City of Portland, Maine - Building or Use Permit Application
 389 Congress Street, 04101 Tel: (207) 874-8703, Fax: (207) 874-8716

BUILDING PERMIT REPORT

REASON FOR PERMIT: To Construct a Fire exit

**THE EARL APARTMENTS
LOWER LEVEL RENOVATIONS**

FLOOR PLAN - PARTIAL BSMT PLAN
SCALE 1/4" = 1'-0"

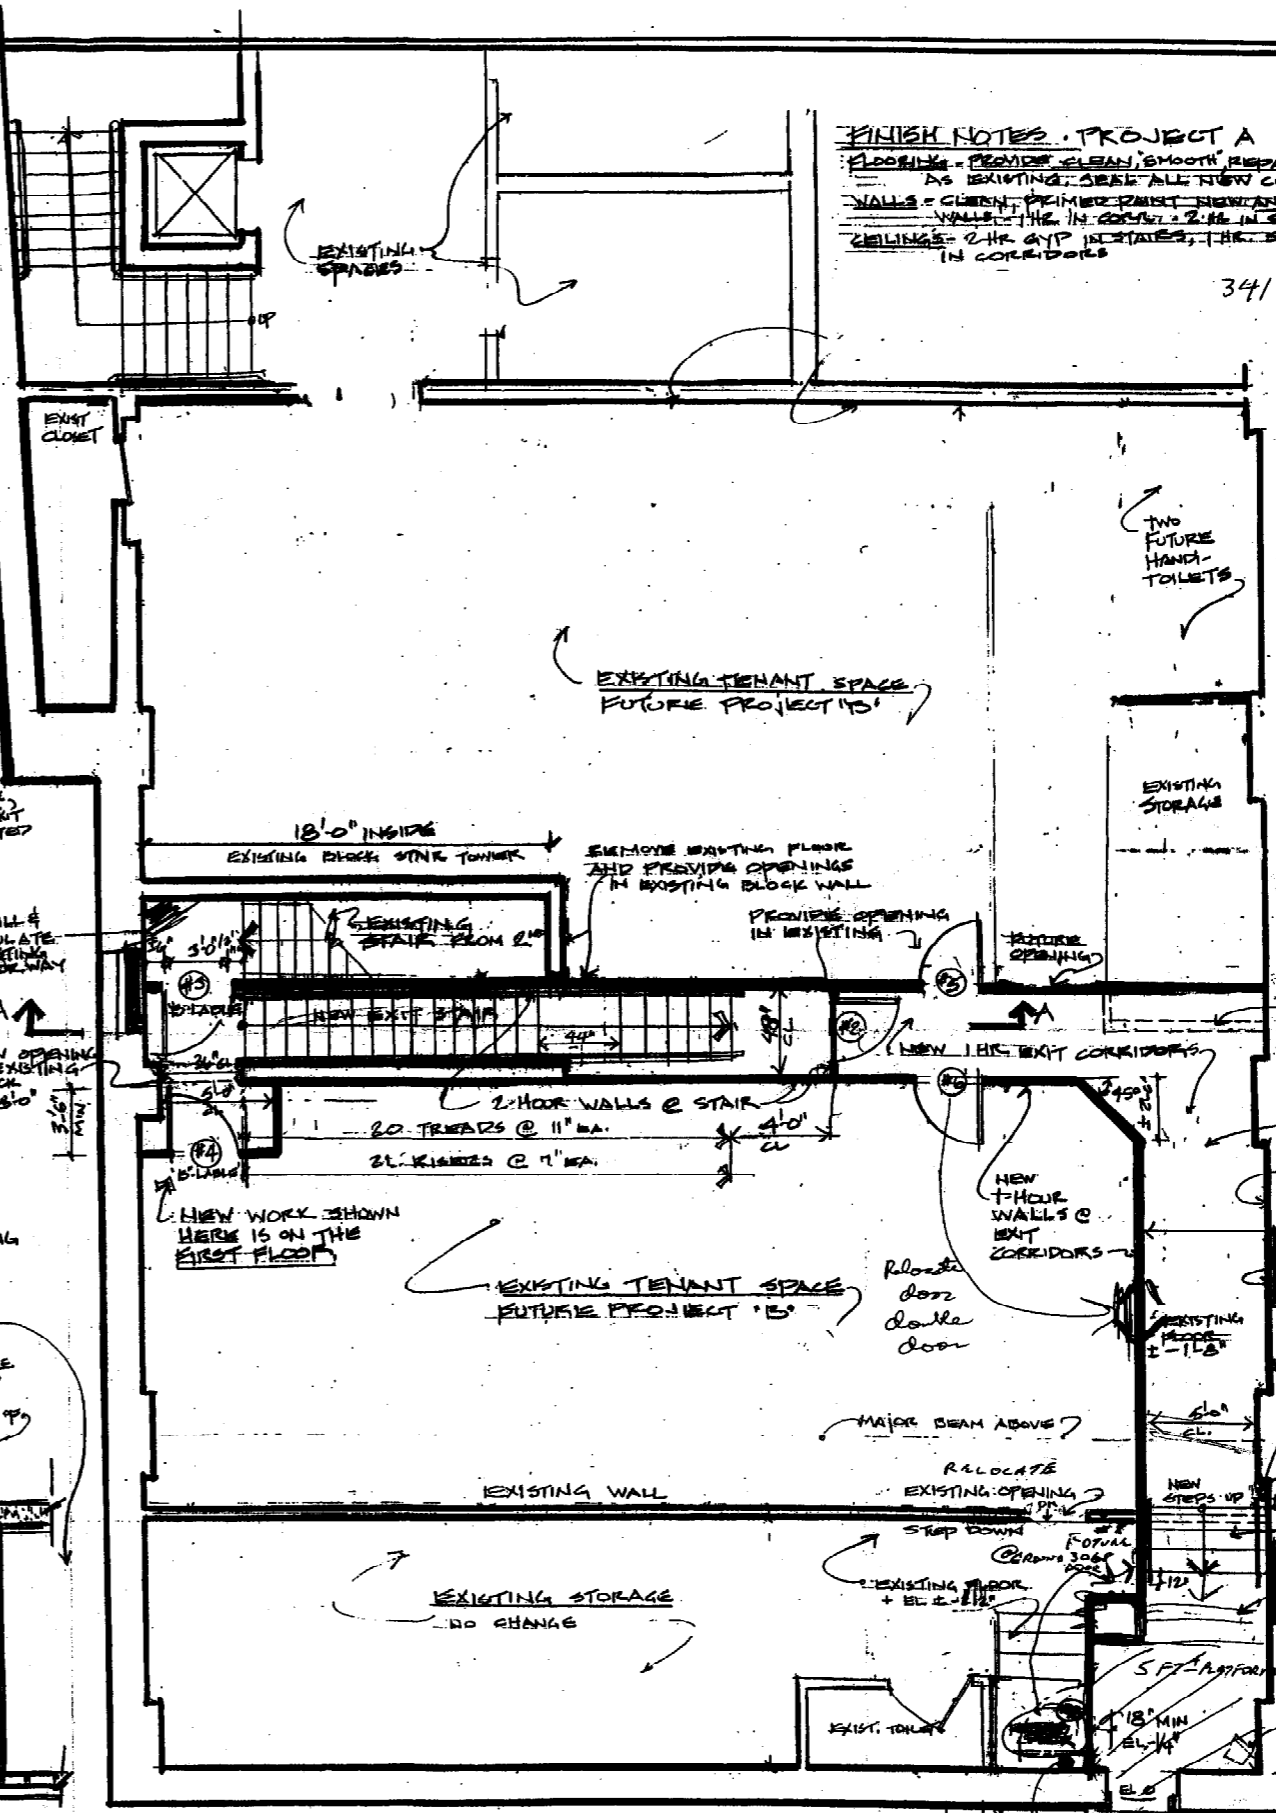
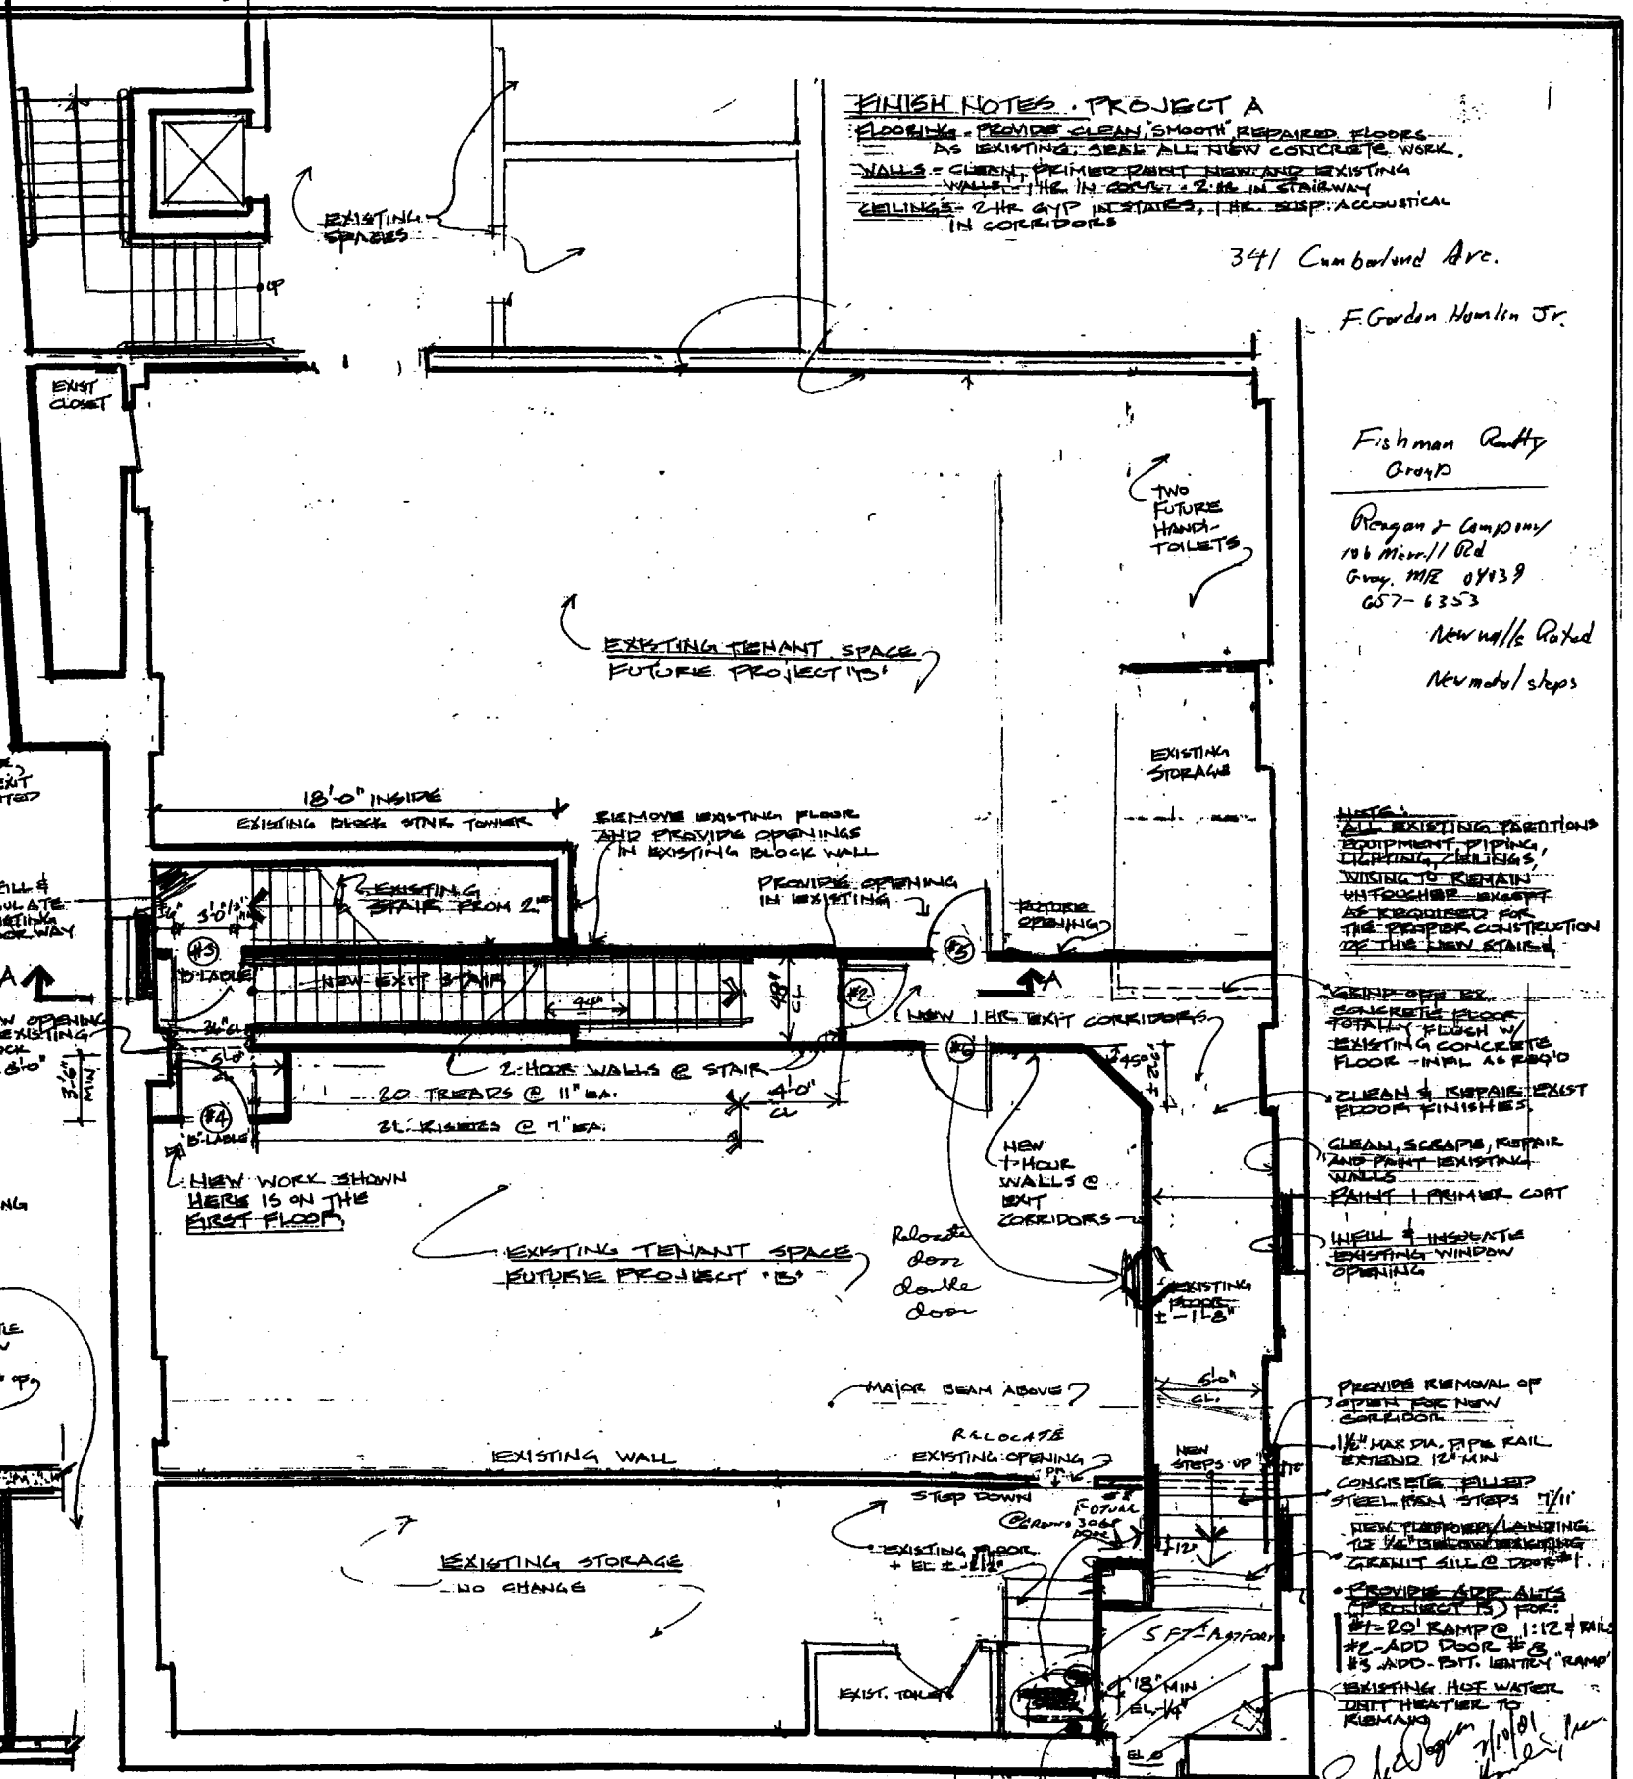
* 39. The hot water tank in an exit shall be enclosed -
